LLFA Response

Selsfield Lane, Ardingly, West Sussex, RH17 6UG

- 1.1. Further to the submission of the Reserved Matters Application (Ref. DM/26/1186) for the above project comments have been received from West Sussex CC LLFA.

Title PROPOSED DRAINAGE STRATEGY SHEET 2 OF 3

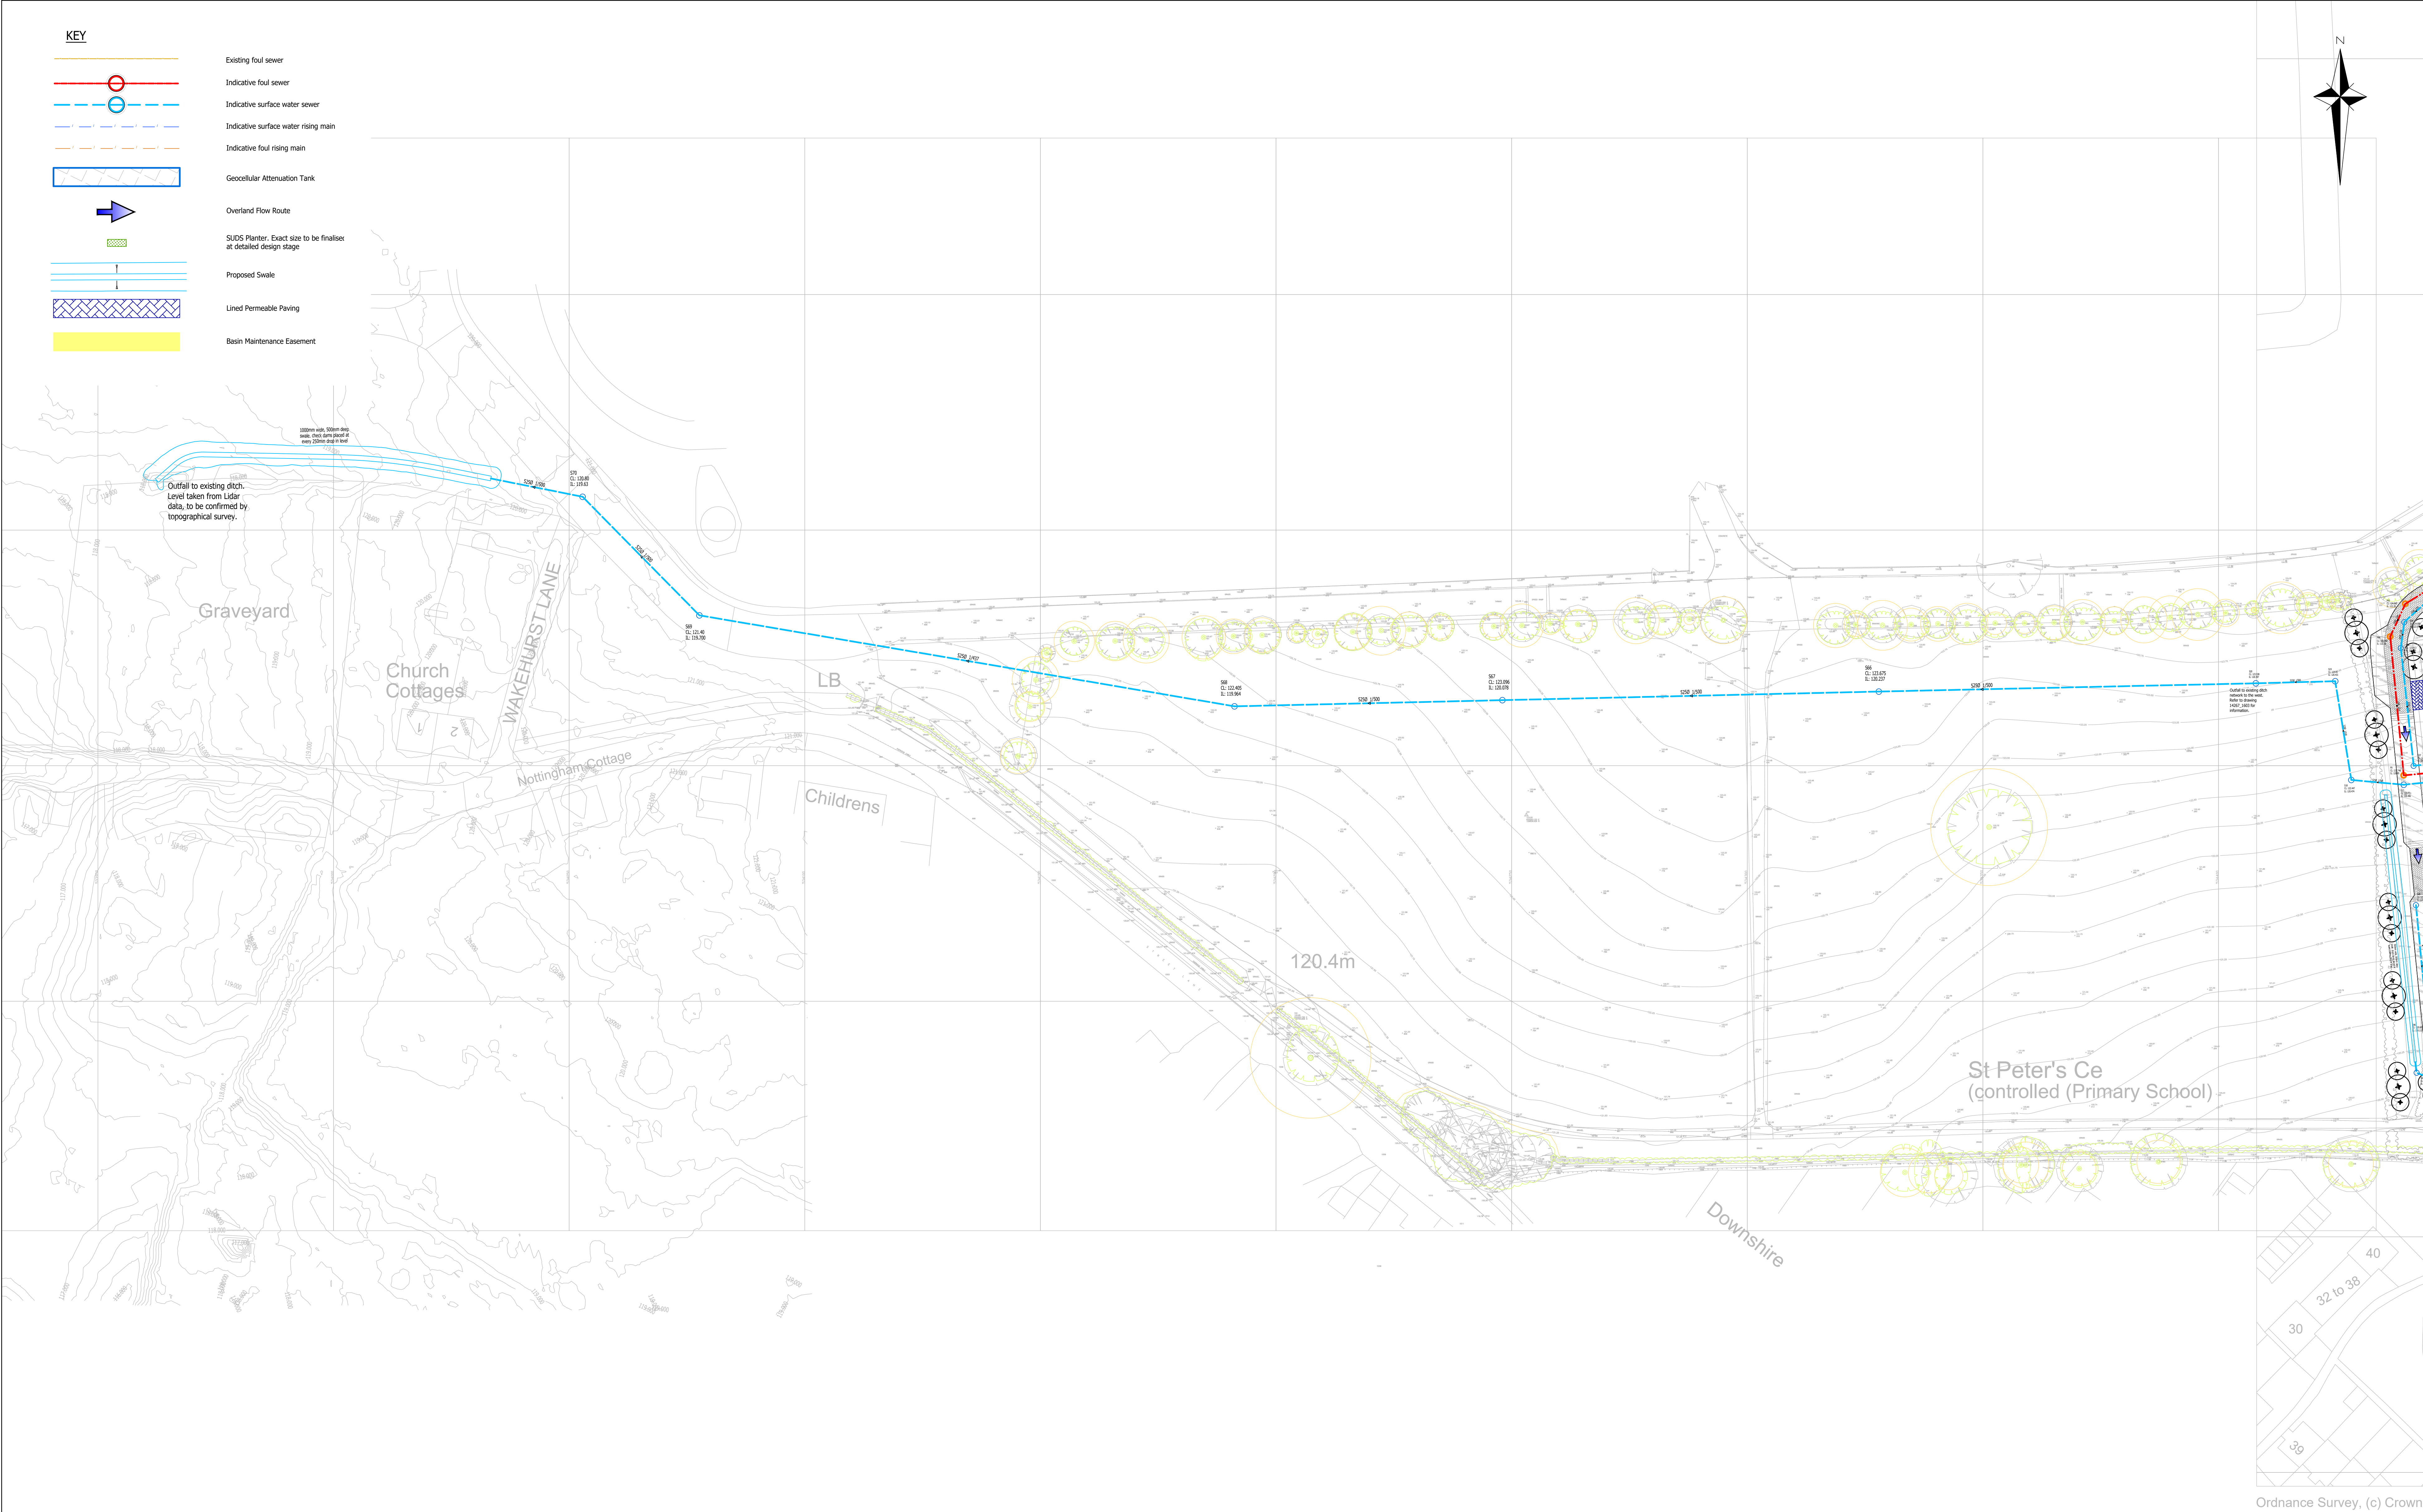
- 1.2.6. While SUDS planters are mentioned in 10.6, the location of these are unclear.
- 1.2.7. Part of the basin is designed with 1:2 side slopes, which does not follow SUDS manual.
- 1.2.8. The exceedance plan must show expected flood volume, depth and area for 1 in 100 plus 45% climate change event.
- 1.2.9. Updated calculations to demonstrate there is no surcharging in 50% AEP event are required,
- 1.2.10. For the southern network, 30 year plus climate change and 100 year plus correct climate change results are required.
- 1.2.11. A drawing showing maintenance responsibilities is required.

6. Indicative SUDS planters now indicated throughout the site, this is subject to detailed design.
7. Basin design has been updated with maximum side slopes of 1:3.

8. Flood volume and area now shown on drainage layout drawings. A depth of 50mm is assumed.
9. The surcharging present in the network during the critical 50% AEP event (Nodes 12, 13, 41, 42, 43 and 56) are a combination of dummy manholes within the basin footprint and water backing up into Nodes 41 and 42 as the basin fills. The surcharging is not caused by insufficient capacity. Updated calculations are included in Appendix C.

Basin Sections Drawing

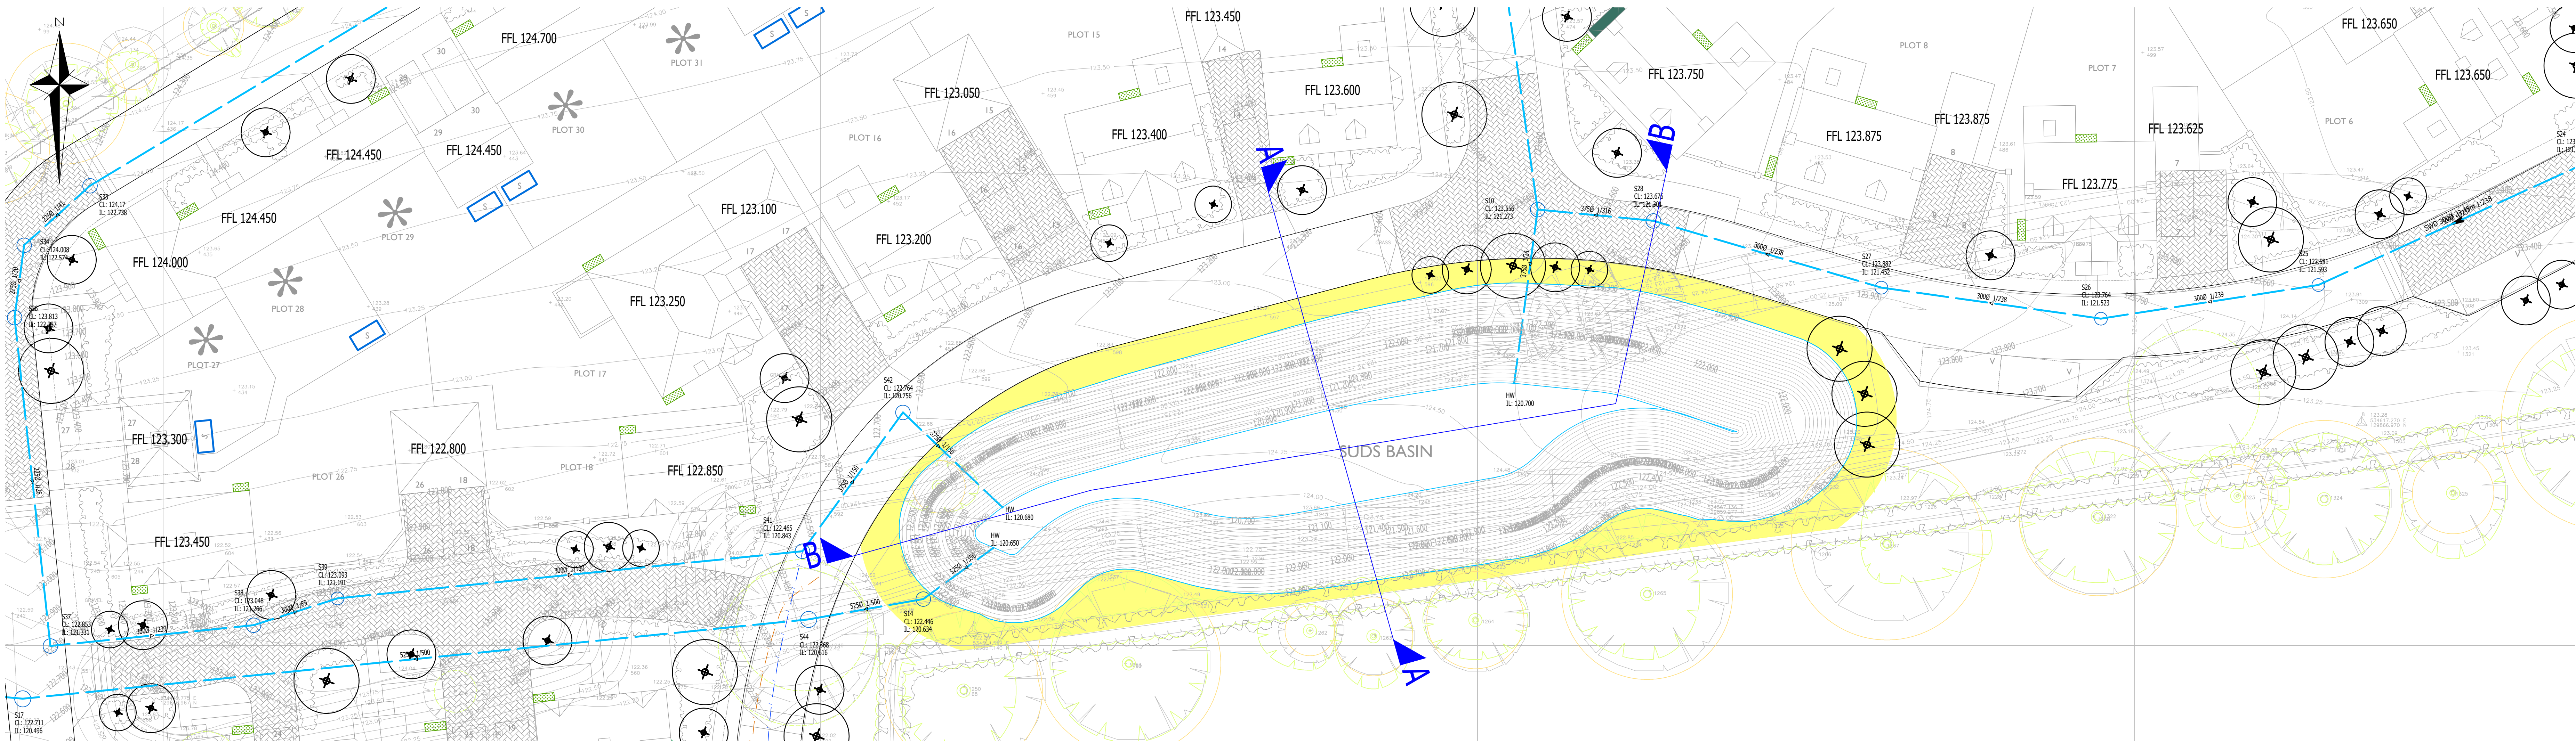
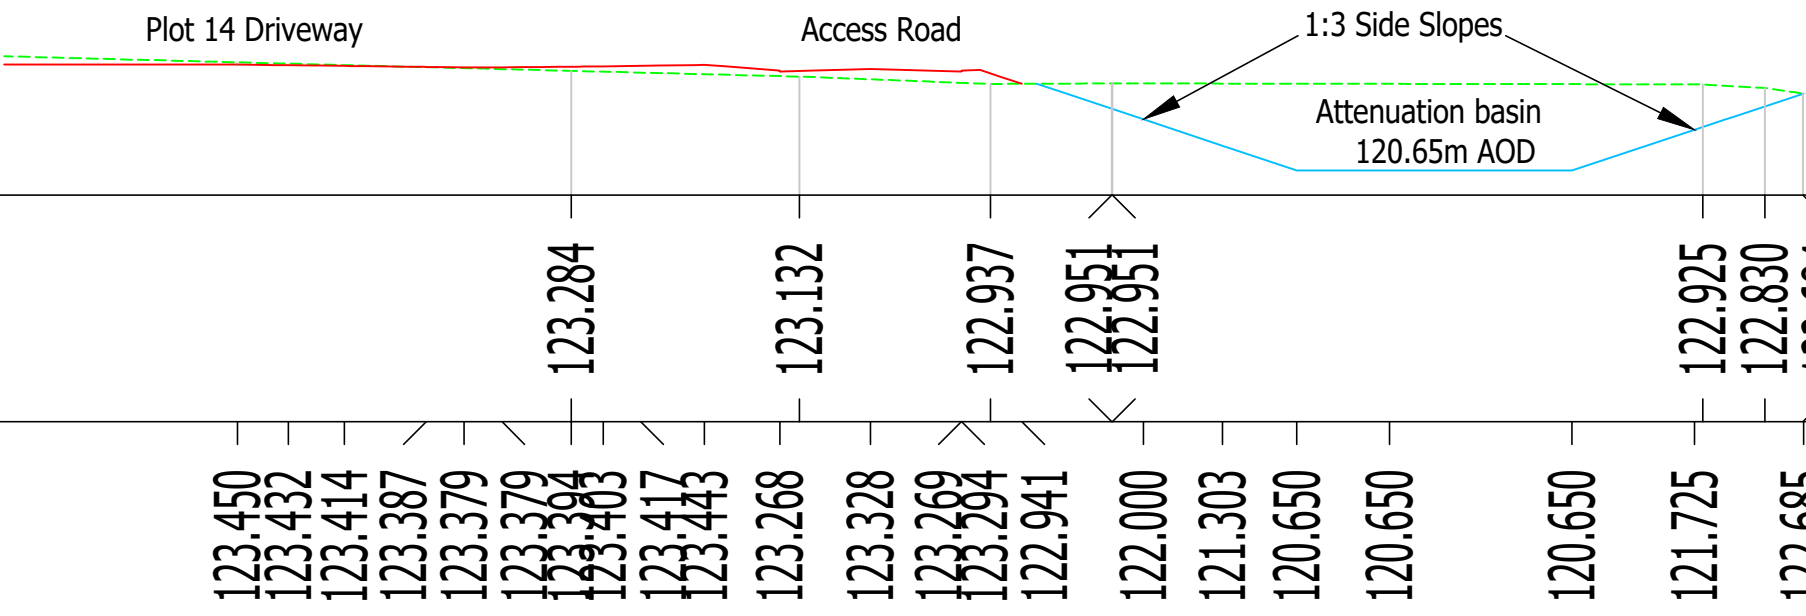
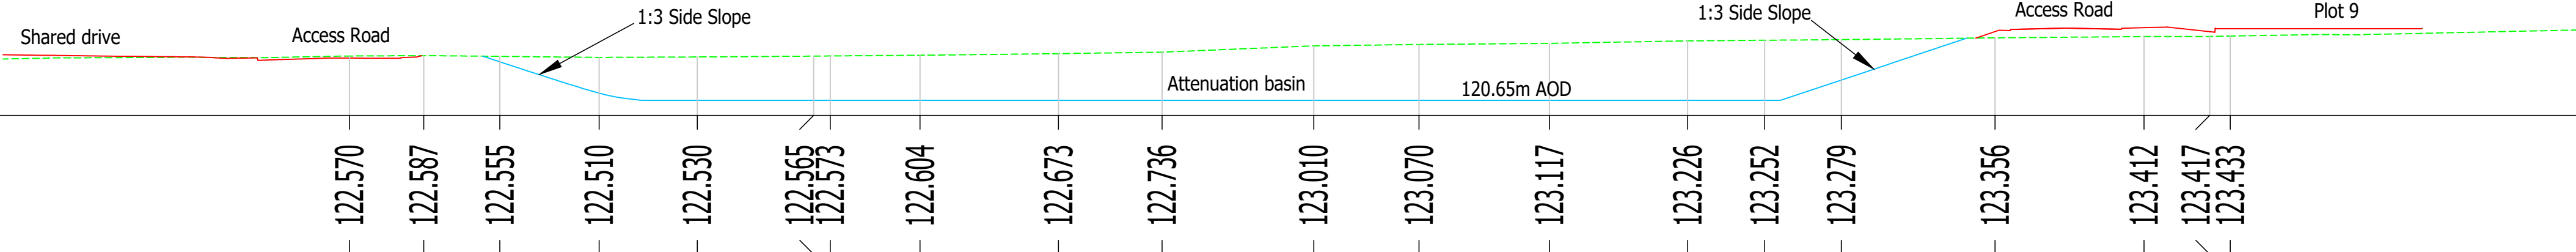
- ii) *A 3m easement around the basin and nearby off-road parking for maintenance access is required.*
 - iii) *Basin cross sections required. It is recommended the basin is designed using guidance in the SUDS manual.*

2. The below image taken from the Scalgo software indicates the connectivity route from the proposed outfall to the existing reservoir. The flow follows Balcombe Lane before entering the reservoir easement. The proposed access road provides an area on the northern side of the basin to undertake maintenance tasks. 3m is available for the majority of the perimeter with the exception of some of the southern edge. We feel this is suitable for the likely maintenance tasks involved. Drawing 14267_1604 is provided in Appendix B indicating proposed sections through the basin.
